EMERGENCY LICENSE AMENDMENT REQUEST
TECHNICAL SPECIFICATION 3/4.2.3
SALEM GENERATING STATION
UNIT NO. 2
FACILITY OPERATING LICENSE DPR-75
DOCKET NO. 50-311

REQUEST FOR AMENDMENT
SALEM GENERATING STATION UNIT NO. 2
FACILITY OPERATING LICENSE DPR-75
DOCKET NO. 50-311

SALEM UNIT NO.2
AFFECTED TECHNICAL SPECIFICATION PAGES

Figure 3.2-3
RCS TOTAL FLOWRATE VERSUS R — FOUR LOOPS
IN OPERATION

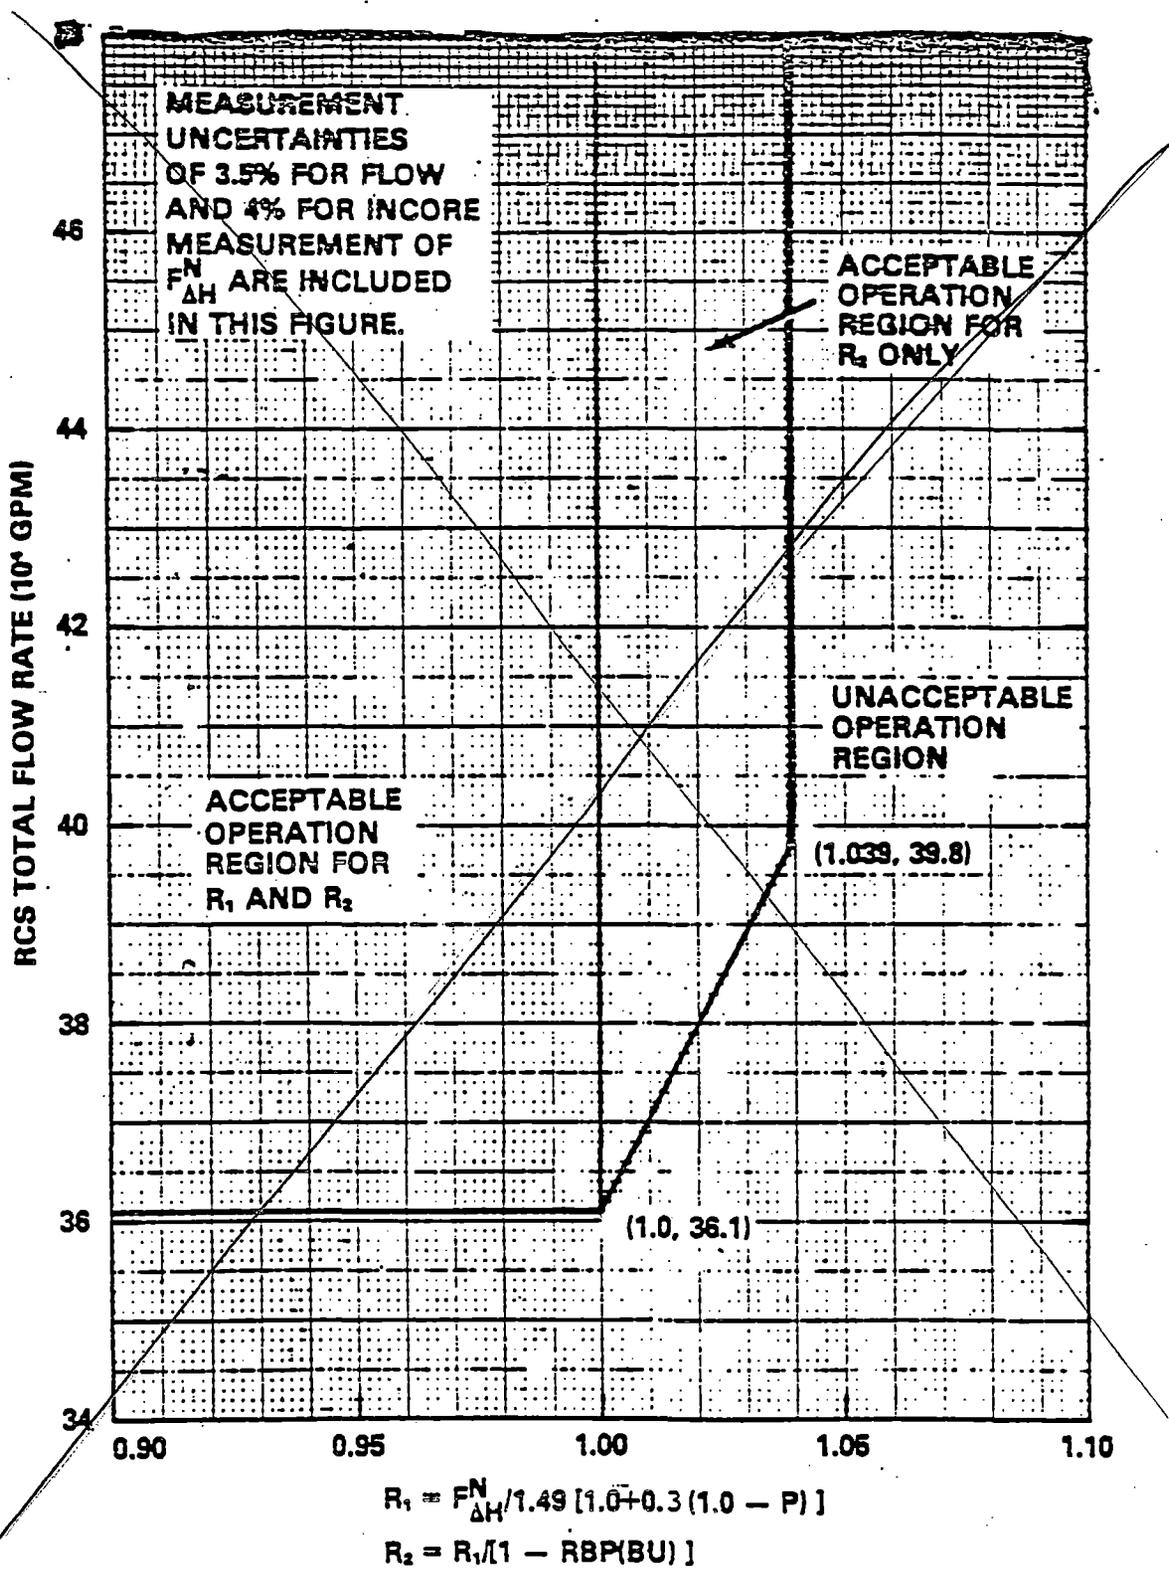
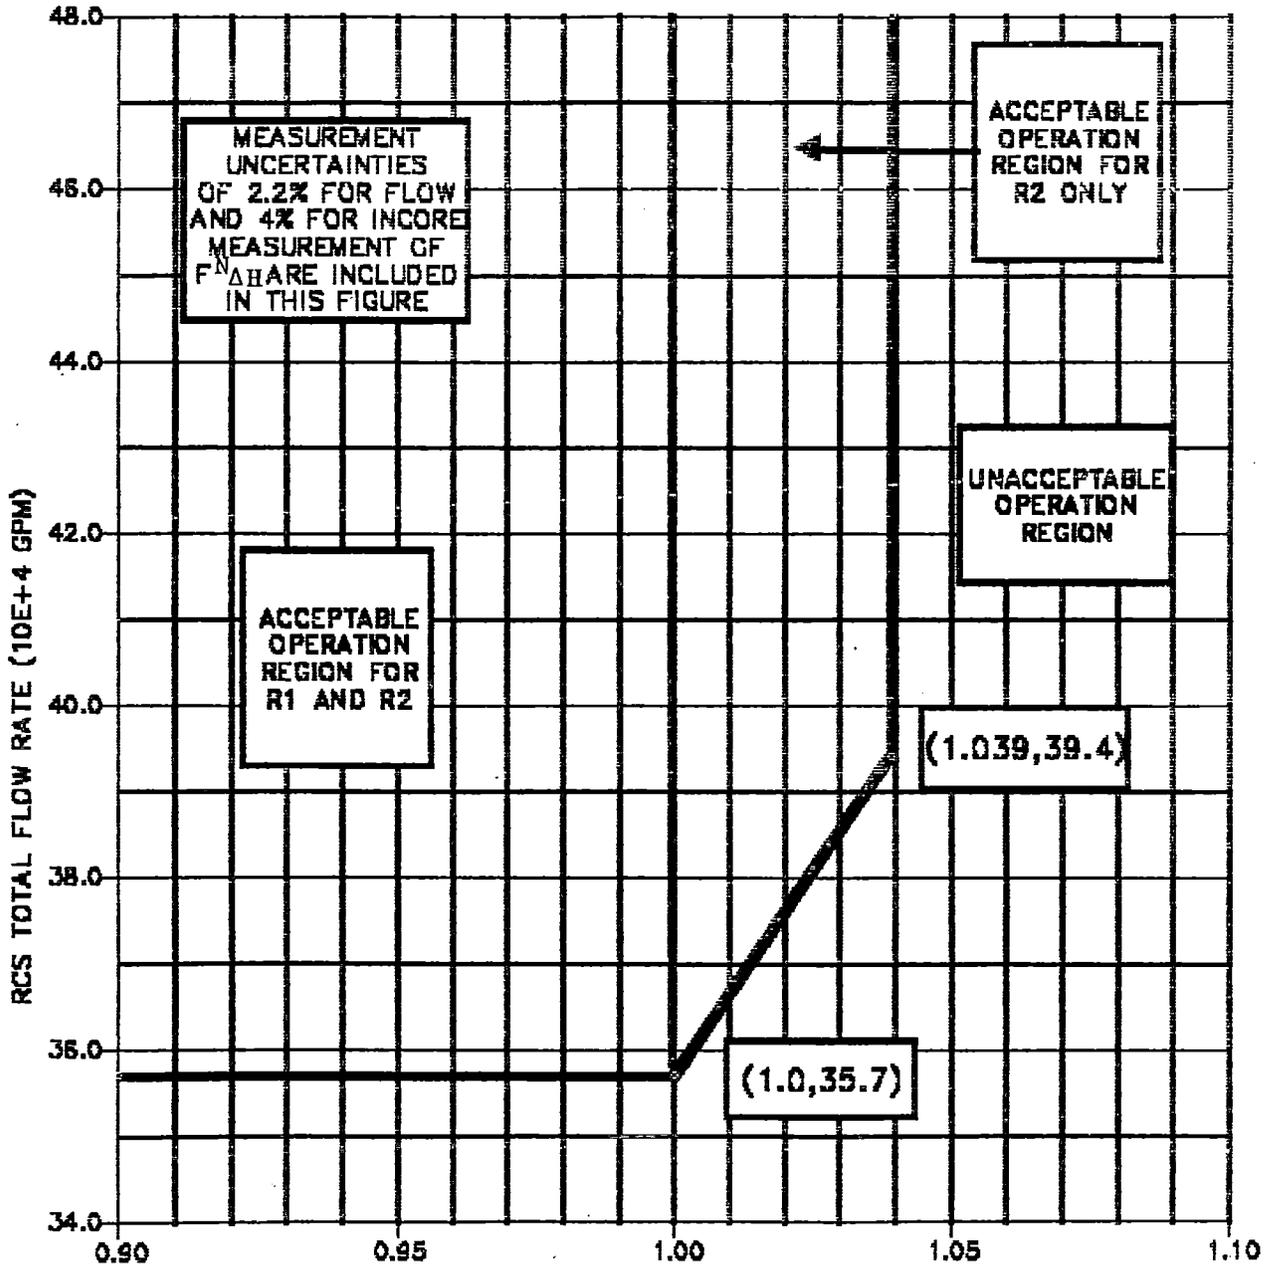
The present RCS Flow correction (3.5%) reflects the uncertainties associated with the previous (i.e. RTD Bypass Loop) RCS narrow range temperature monitoring system. Thermal design flow (TDF) rate is a key parameter established during the calculation of the design DNBR value. Once established, the thermal design flow rate must then be corrected for measurement uncertainties to establish a minimum allowable flow rate for safe plant operation. The minimum allowable flow (MAF) rate shown in Figure 3.2-3 is determined by applying the uncertainty value in the following fashion;

d. $F_{\Delta H}^N$ = Measured values of $F_{\Delta H}^N$ obtained by using the movable incore detectors to obtain a power distribution map. The measured values of $F_{\Delta H}^N$ shall be used to calculate R since Figure 3.2-3 includes measurement uncertainties of ~~3.5%~~ for flow and 4% for incore measurement of $F_{\Delta H}^N$. 2.2%

REPLACE WITH NEW FIGURE 3.2-3

Specification 3/4.2.3, RCS Flow And R, and Figure 3.2-3 establish a minimum allowable RCS flow rate of $36.1E4$ gpm. This flow rate is based on a thermal design flow rate of $8.73E4$ gpm per loop with a 3.5% correction for flow measurement uncertainties. The requested change reduces the RCS Flow uncertainty correction to 2.2% and revises Figure 3.2-3 to reflect the appropriate adjustments to the minimum flow limit. Miscellaneous typographical corrections are also made.

Figure 3.2-3 is adjusted to allow for a 2.2% error in RCS flow rate and a 4% error in for $F_{\Delta H}^N$. The correction for RCS flow was reduced as a result of the replacement of the RTD Bypass Loops with thermowell RTDs. The detailed justification for the reduction is contained in WCAP-11579 (Proprietary) dated September 1987.
